Financial Assurance Policy:

January 08, 2010

Item 2

Drawing 1 of 2

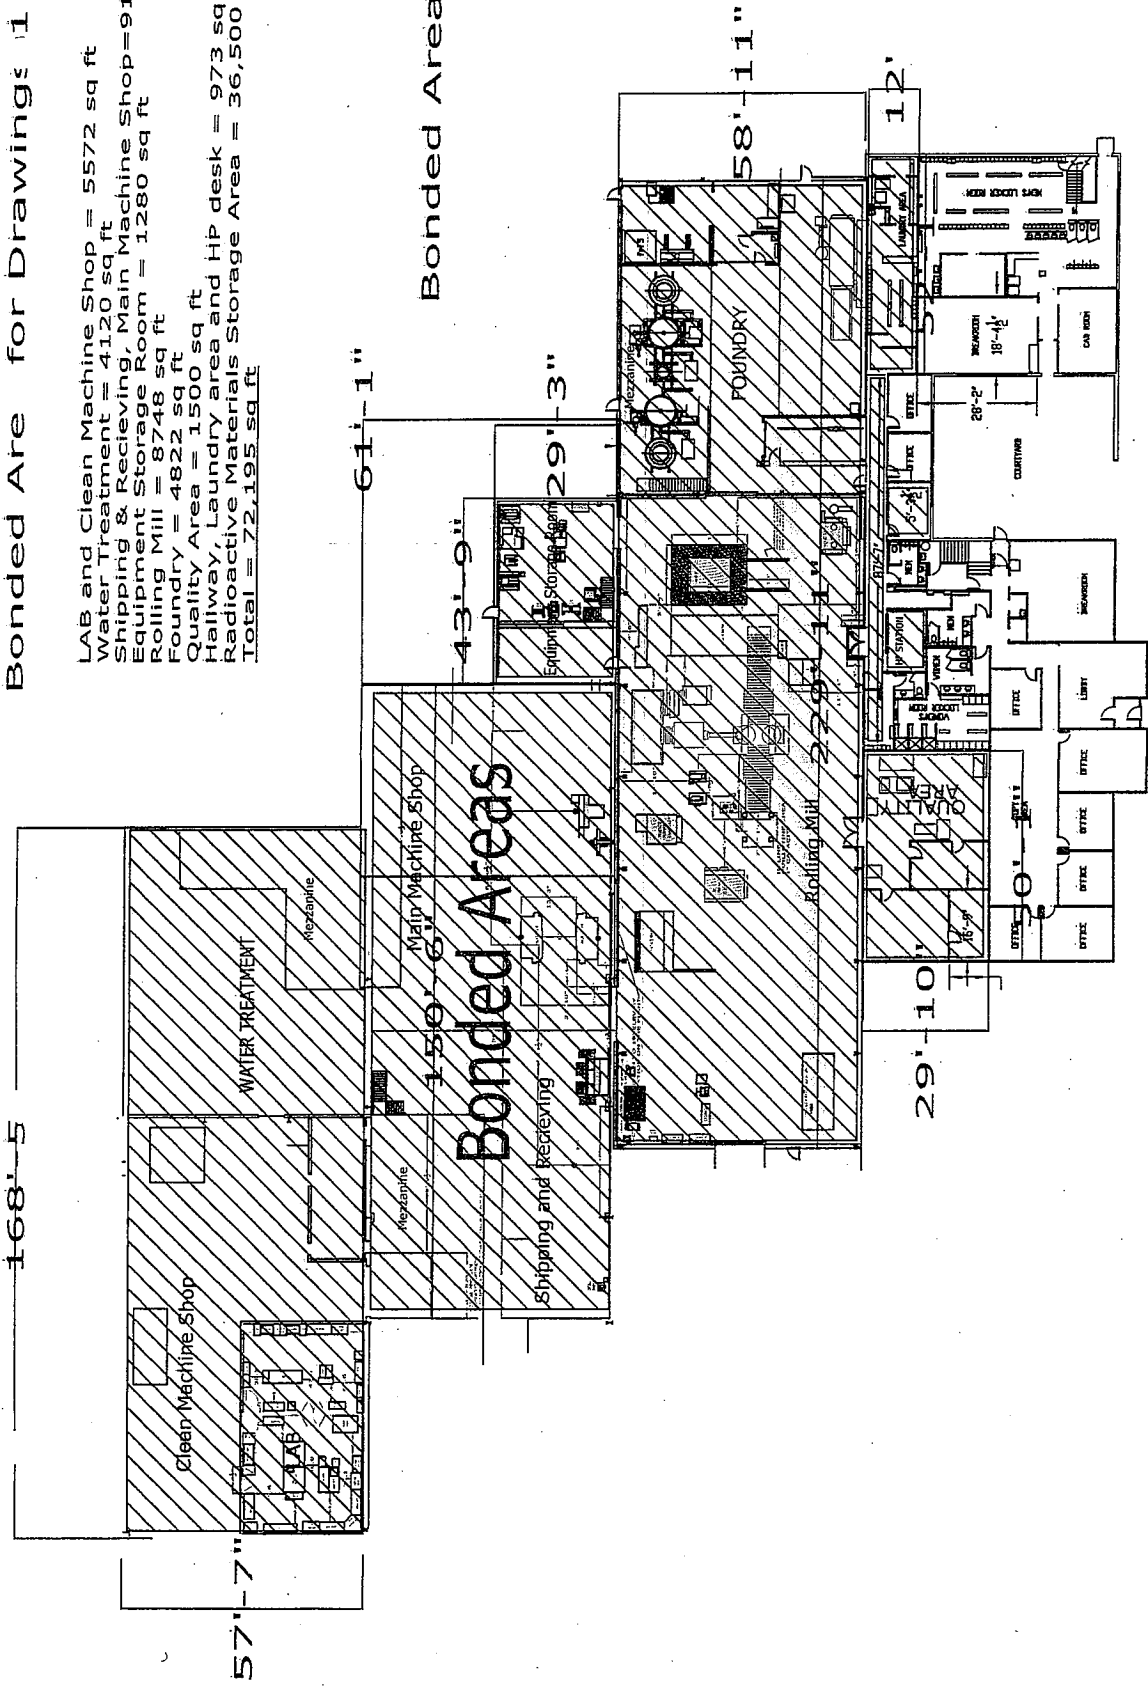
Submit a summary of dimensions and square feet for financially assured (bonded) areas in Attachment 3 of the application including the areas for 4 high stacking (11.8 RSG-1) that show that these areas are covered within the current financial assurance amount of \$7,793,153.00. The 4 high stacking areas must be multiplied by 4.

Response: Included are floor prints with dimensions and square footage noted for financially assured areas. proposes to stack sea land containers 3 high within the Radioactive Materials Storage Area. proposes to stack intermodal containers 4 high but these stacking heights equate to a similar volume to 3 high sea land containers stacked. In reviewing the current Letter of Credit on file with the TDRH the amount assured matches the footprint including using a 3X factor for the Radioactive Materials Storage Area. Two copies of the floor prints are included to be added to Attachment 3 of the "Application for Source Material License Renewal".

- LAB and Clean Machine Shop = 5572 sq ft
- Water Treatment = 4120 sq ft
- Shipping & Receiving, Main Machine Shop = 9180 sq ft
- Equipment Storage Room = 1280 sq ft
- Rolling Mill = 8748 sq ft
- Foundry = 4822 sq ft
- Quality Area = 1500 sq ft
- Hallway, Laundry area and HP desk = 973 sq ft
- Radioactive Materials Storage Area = 36,500 sq ft
- Total = 72,195 sq ft**
